**PLANNED UNIT DEVELOPMENT
& SUBDIVISION STAFF REPORT****Date: October 4, 2012****DEVELOPMENT NAME**

Taylor Place Subdivision, Resubdivision of Lot 4

Planned Unit Development Approval to amend a previously approved Planned Unit Development to reduce the minimum building setback line and a drainage easement, and Subdivision approval to amend the recorded building setback line and remove a portion of a drainage easement on a previously approved subdivision lot.

SITE PLAN

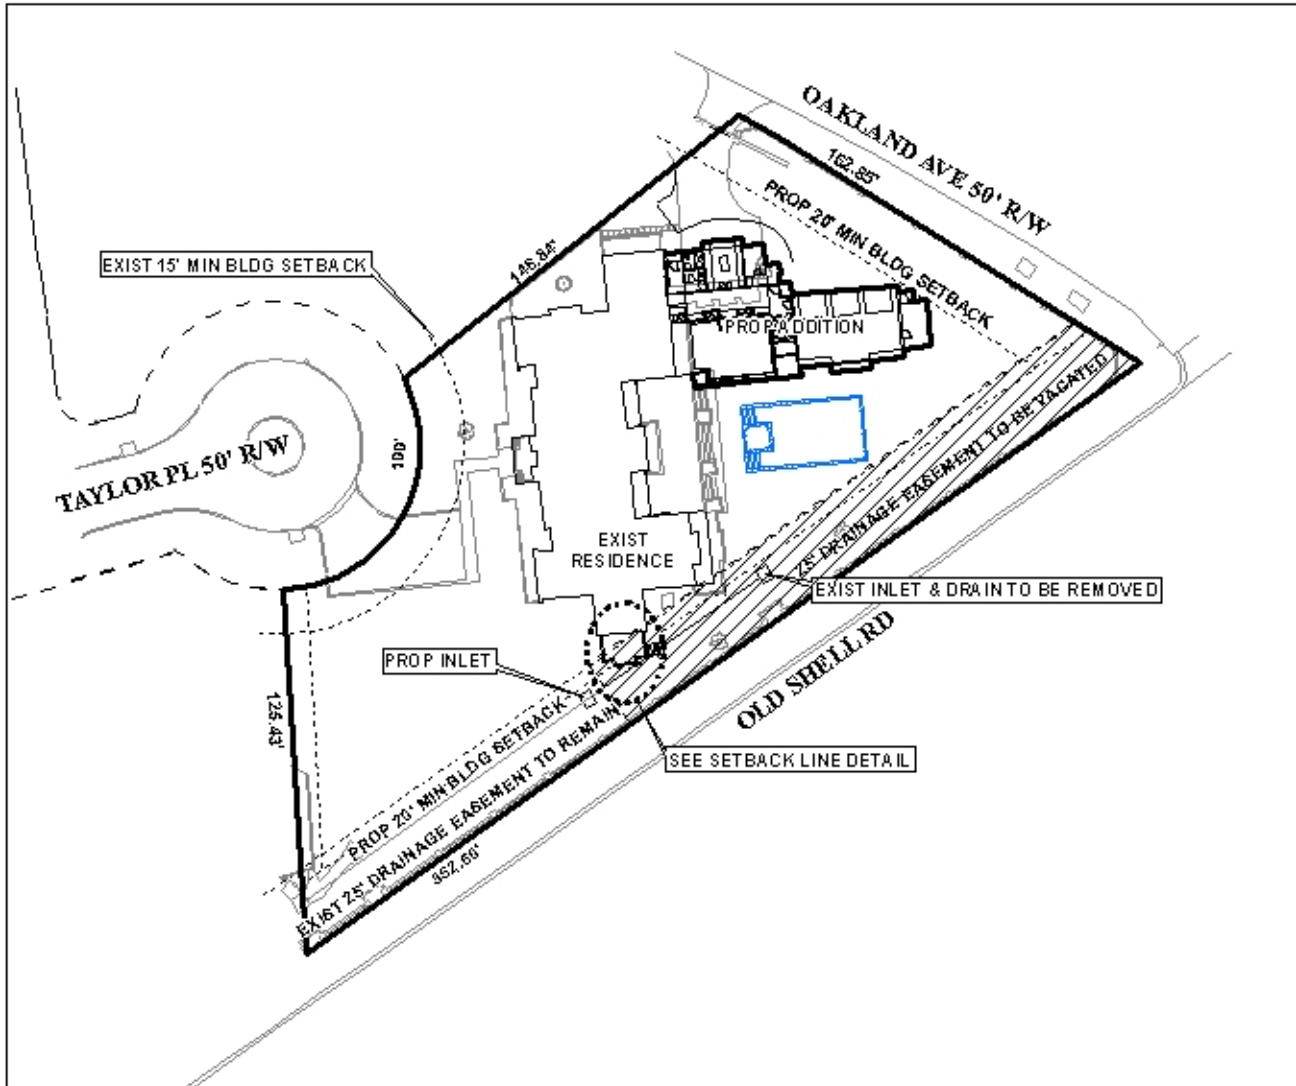
The 25' minimum building setback line and the 25' drainage and utility easement along Old Shell Road were both recorded on the plat for Taylor Place Subdivision. Only the 25' minimum building setback line was indicated on the original PUD. The applicant proposes to amend the setback line for its entire length on the lot along Old Shell Road and vacate a little more than the Eastern half of the easement. City Engineering has jurisdiction over drainage easements and has indicated that there is no issue with that department concerning the vacation of the easement. However, as the easement is also indicated to be for utilities, the consent to vacation would have to be given by all active and/or potential users of the easement and ultimately approved by the City Council. Therefore, a condition of approval of both the Subdivision and PUD must be the granting of the vacation of the easement by the City Council. If approved, the remaining portion of the easement should be indicated on both the Final Plat for this application as well as an amended PUD site plan.

The request for the 20' minimum building setback line along Old Shell Road would seem in order as this is an innovative private street subdivision, and the lot is completely enclosed along the public street frontages with a high masonry wall; therefore, the allowance of a reduced setback along Old Shell Road would be of little consequence. However, as the easement in question is 25' wide, no building setback line encroachment into such can be allowed. Therefore, the approval of the requested 20' building setback line must be contingent upon the vacation of the easement. But the vacation of the Eastern-most portion of the easement still would not allow the 20' building setback line within the remaining Western-most portion of the 25' easement. If the easement vacation is granted, the building setback line may only be adjusted within the area of the vacation and not in any portion where the easement remains 25' wide.

As previously mentioned, the originally-approved PUD indicated building limit lines which were not indicated on the recorded plat of Taylor Place Subdivision. The 25' minimum building setback line along Old Shell Road and the 20' minimum building setback line along Oakland Avenue were recorded as well as the 15' minimum front building setback line along Taylor Place. However, a 15' building limit line along both the West and North property lines were not recorded. A recorded 7.5' drainage and utility easement along the West property line was not indicated on the original PUD. The fact that the 15' building limit lines were not recorded may or may not have contributed to the encroachment of the existing residence into those limits (and the standard 8' side yard setback) along the North side of the property. The proposed additions meet the 15' limit and the recorded 20' setback along Oakland Avenue. However, to correct the encroachments into both the original PUD limits and the standard 8' side yard setback, the amended PUD should indicate the 15' building limit line along the North side of the property, adjusted to dodge around existing structures. The 15' building limit line should also be illustrated along the West property line as in the original approval. The lines should also be indicated on the Final Plat for the Subdivision.

- 1) completion of the Vacation process for the Eastern-most portion of the drainage and utility easement;
- 2) revision of the site plan to illustrate the 20' minimum building setback line along Old Shell Road, only within the area of the vacated easement, adjusted around the encroaching landing, stairs, and brick planter;

- 3) revision of the site plan to illustrate the existing 25' minimum building setback line remaining along Old Shell Road where the easement is not vacated and remains 25' wide;

- 4) illustration of the 20' minimum building setback line along Oakland Avenue;
- 5) revision of the site plan to illustrate the 15' building limit line of the original PUD along the West property line;

- 6) revision of the site plan to illustrate the 15' building limit line of the original PUD along the North property line, adjusted around any existing building encroachments;

SETBACK LINE DETAIL

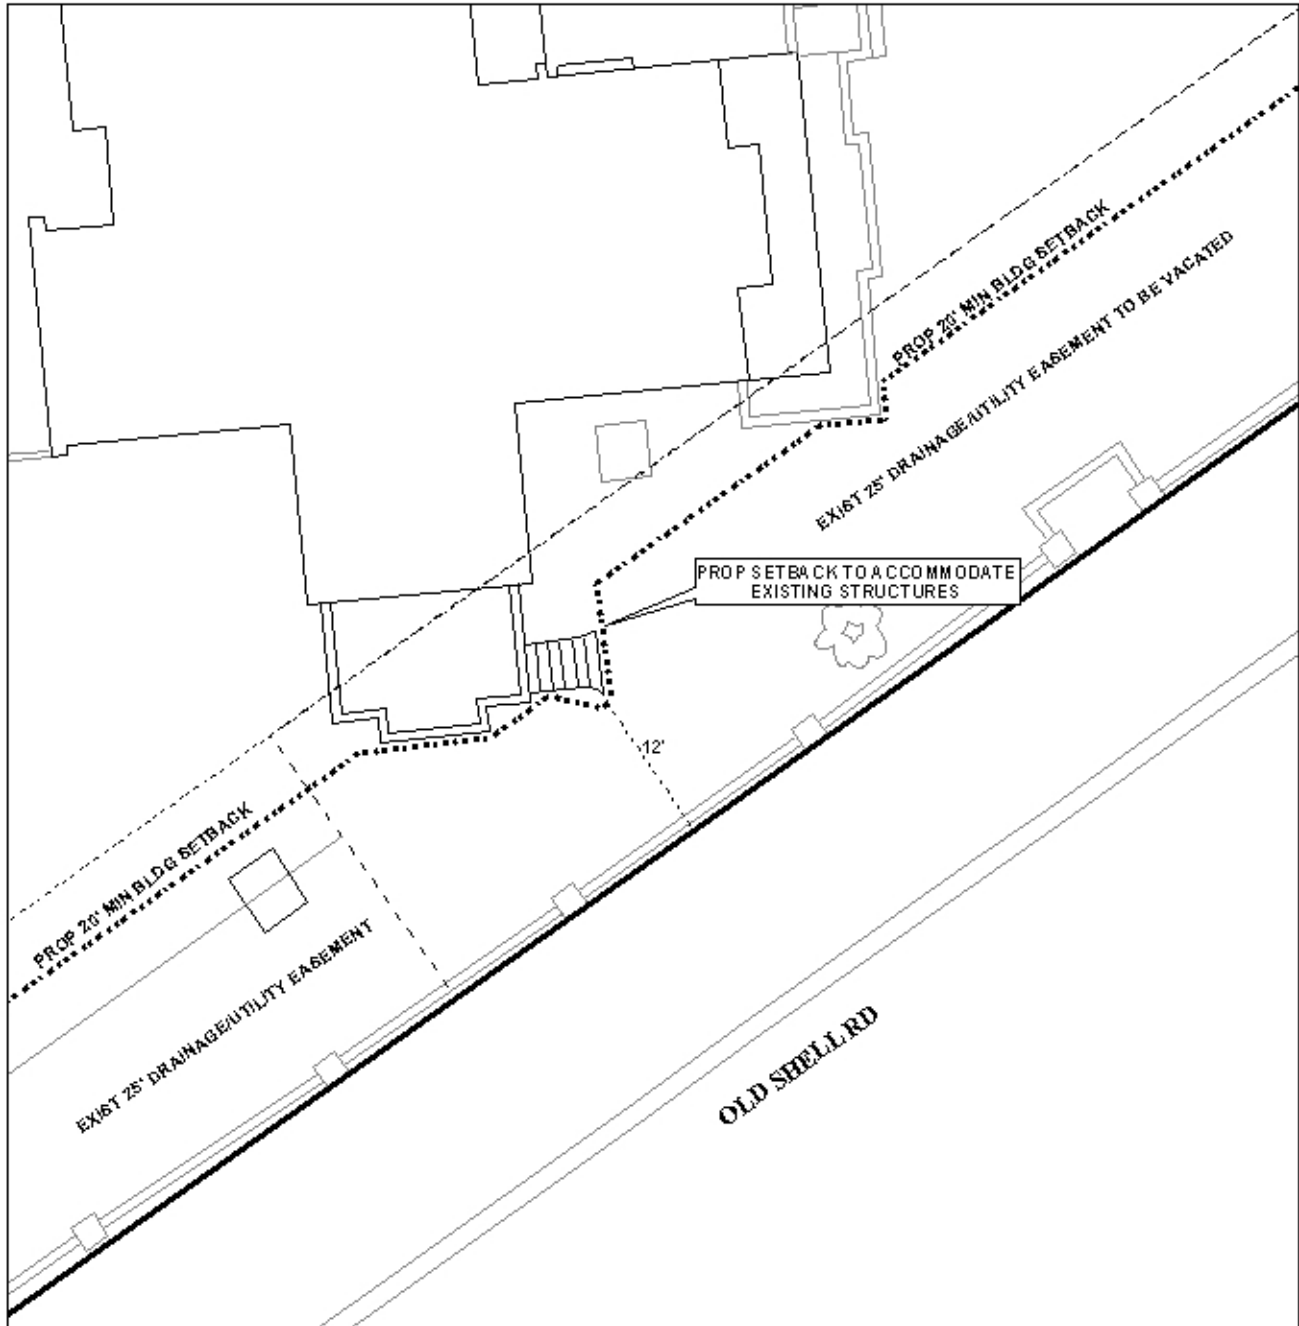
- 1) completion of the Vacation process for the Eastern-most portion of the drainage and utility easement prior to signing the Final Plat;
- 2) illustration of the 20' minimum building setback line along Old Shell Road, only within the area of the vacated easement, adjusted around the encroaching landing, stairs, and brick planter;

- 3) revision of the plat to illustrate the existing 25' minimum building setback line remaining along Old Shell Road where the easement is not vacated and remains 25' wide;
